ADDENDUM NO. 1

LOWER VALLEY WATER DISTRICT

PANORAMA VILLAGE LIFT STATION 19 (PACKAGE 4)

BID No. 24-0105-01

JOB NO. 21-117
3 SHEET NUMBER 8
E3.0

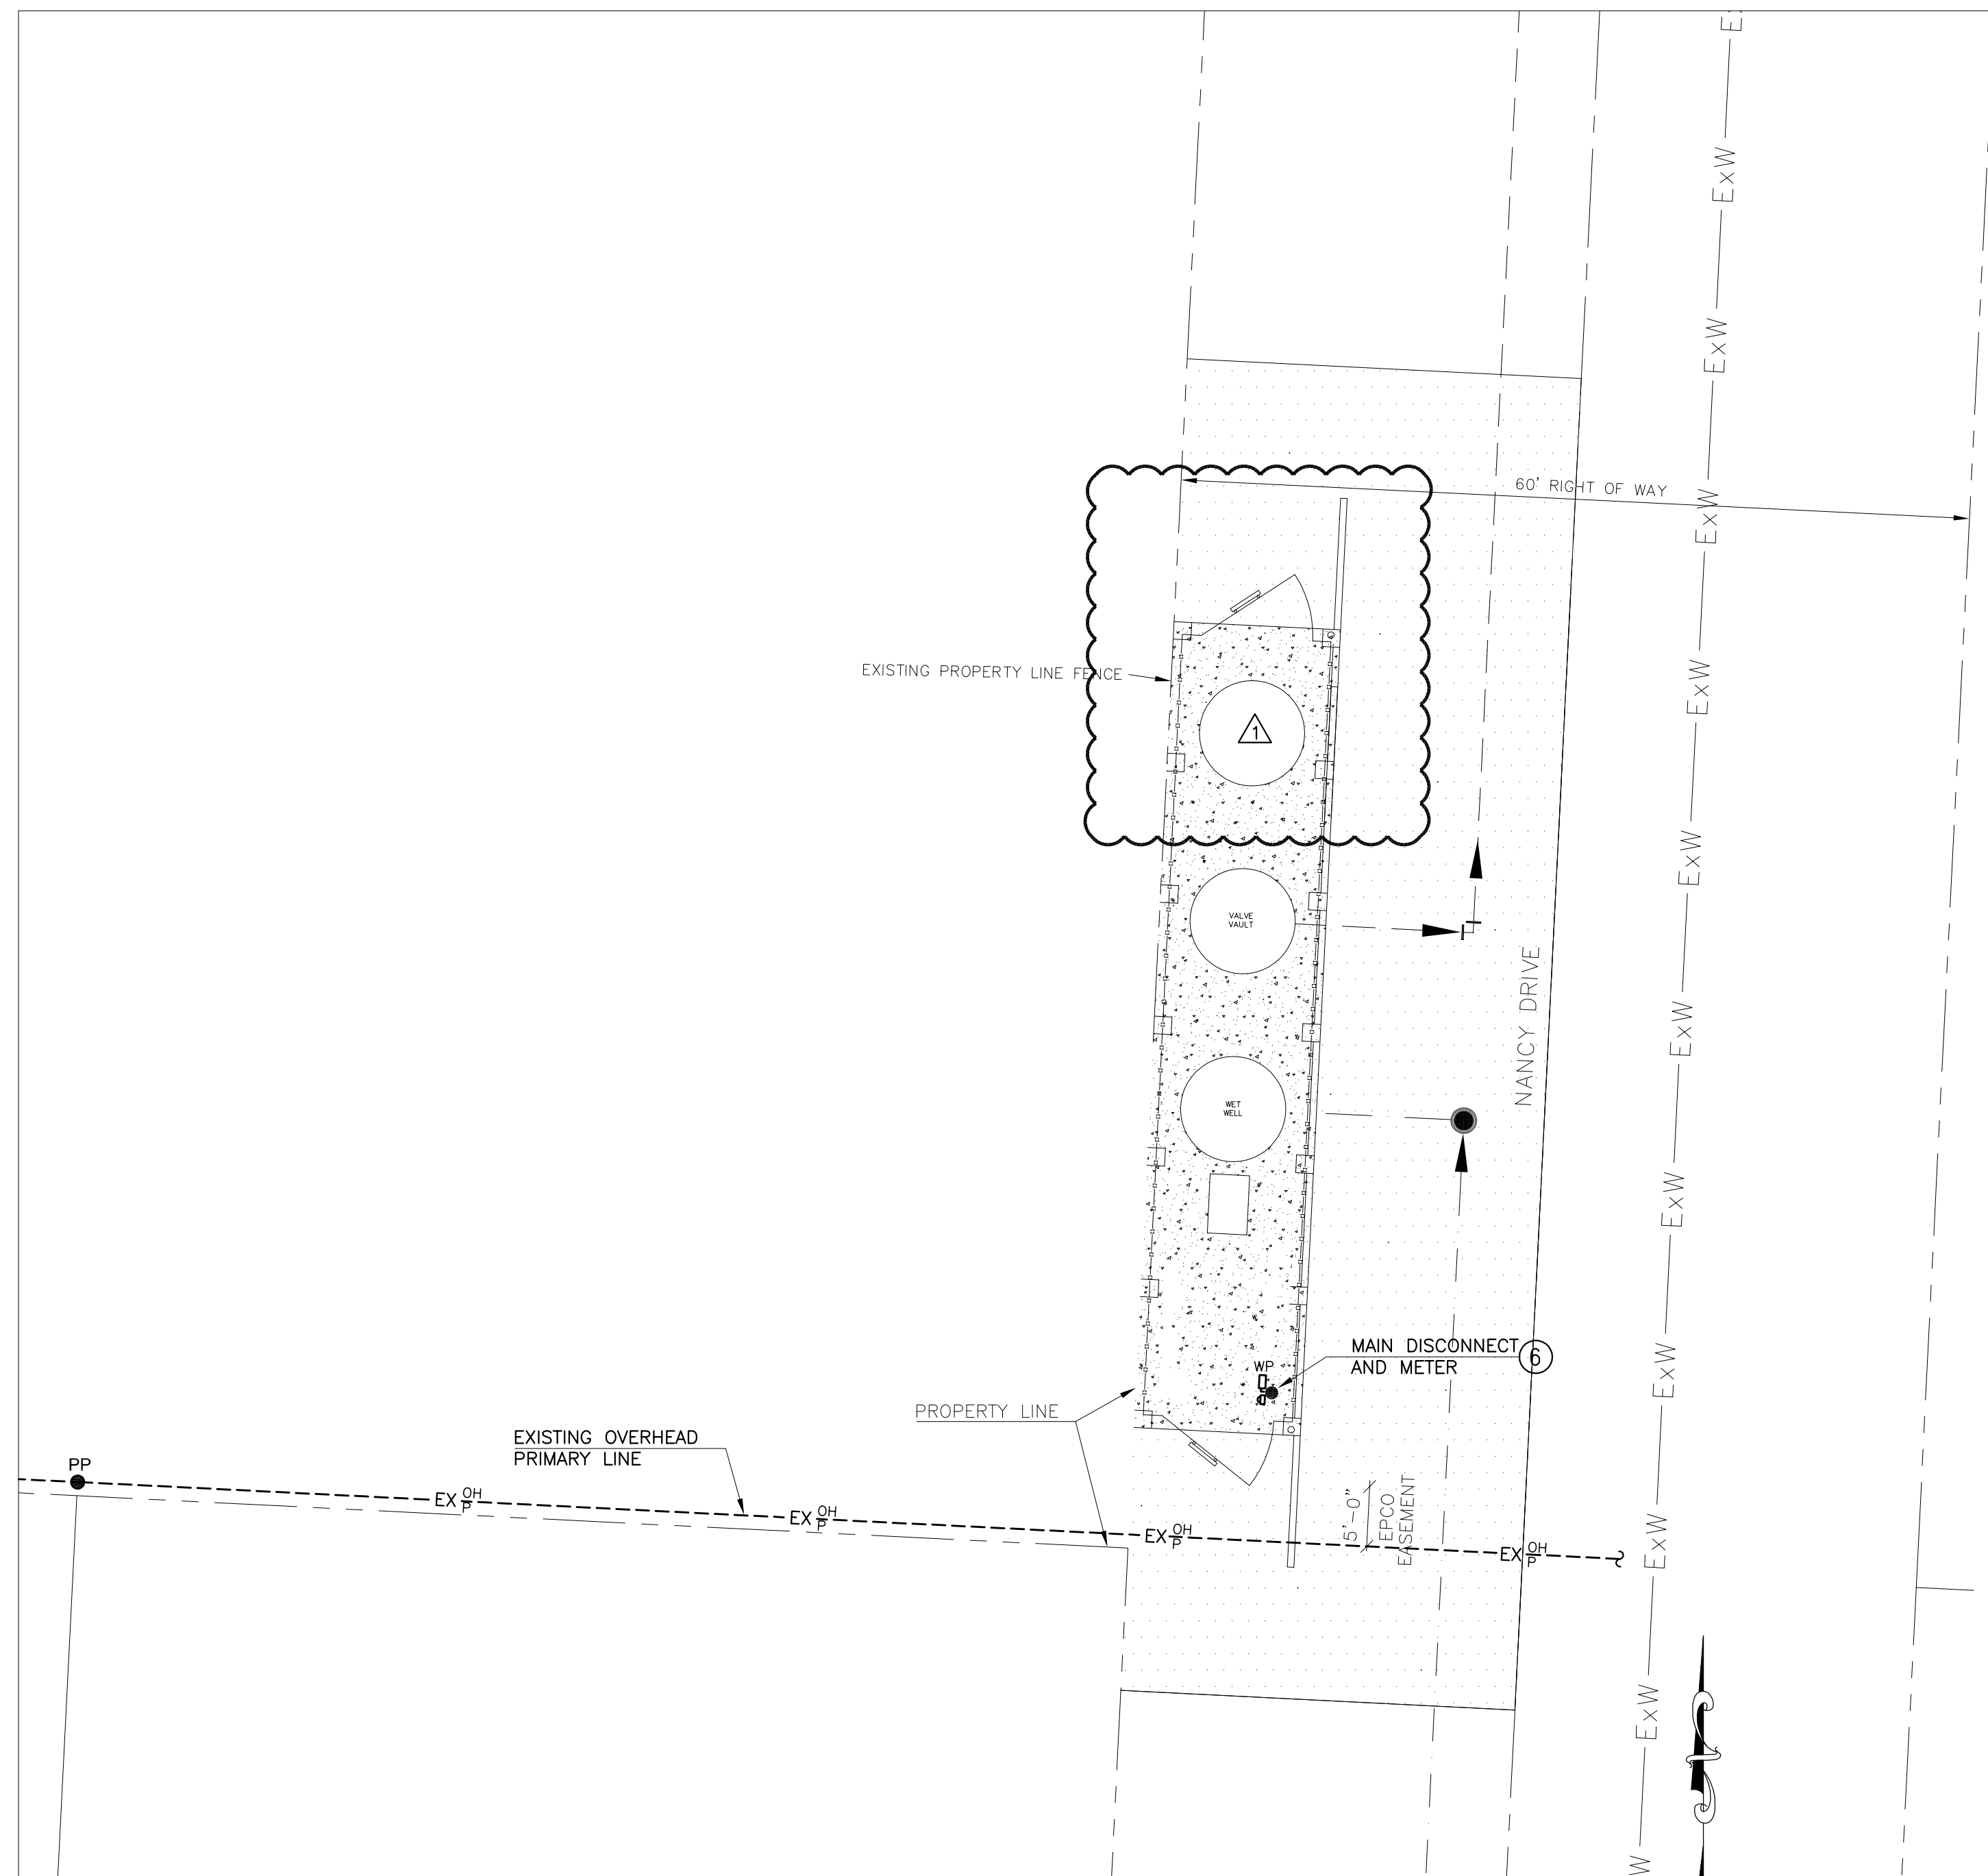
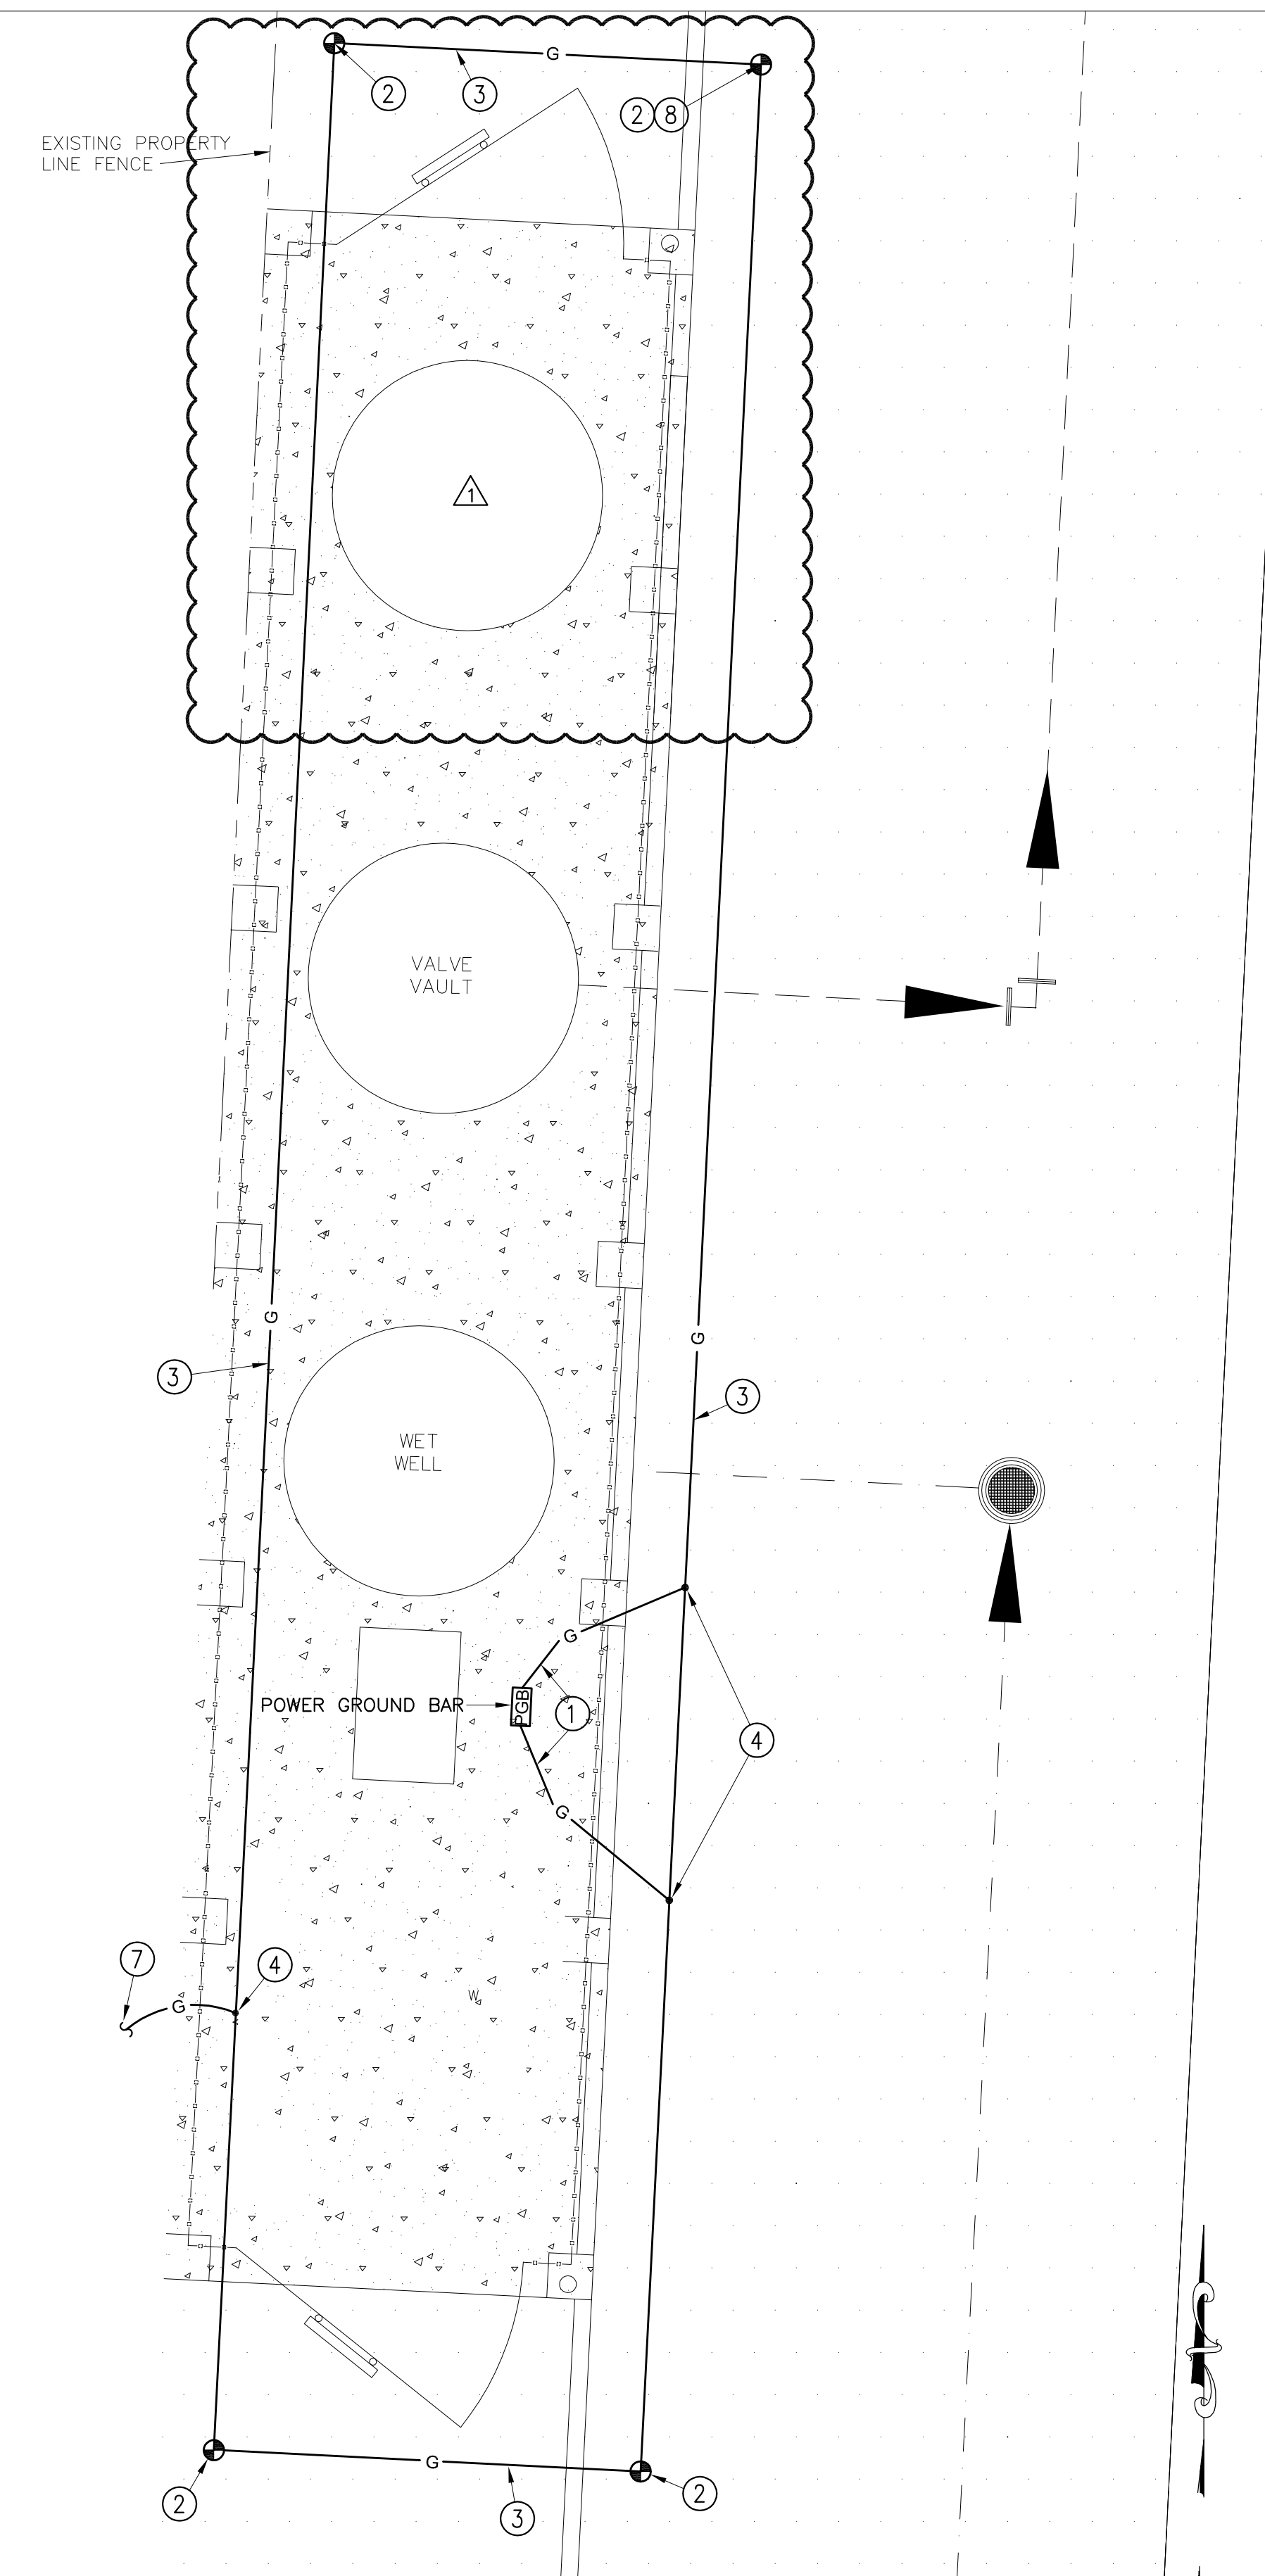
REV.	DATE	BY	DESCRIPTION
1	12/22/23	G.A.	MODIFIED CONCRETE SLAB
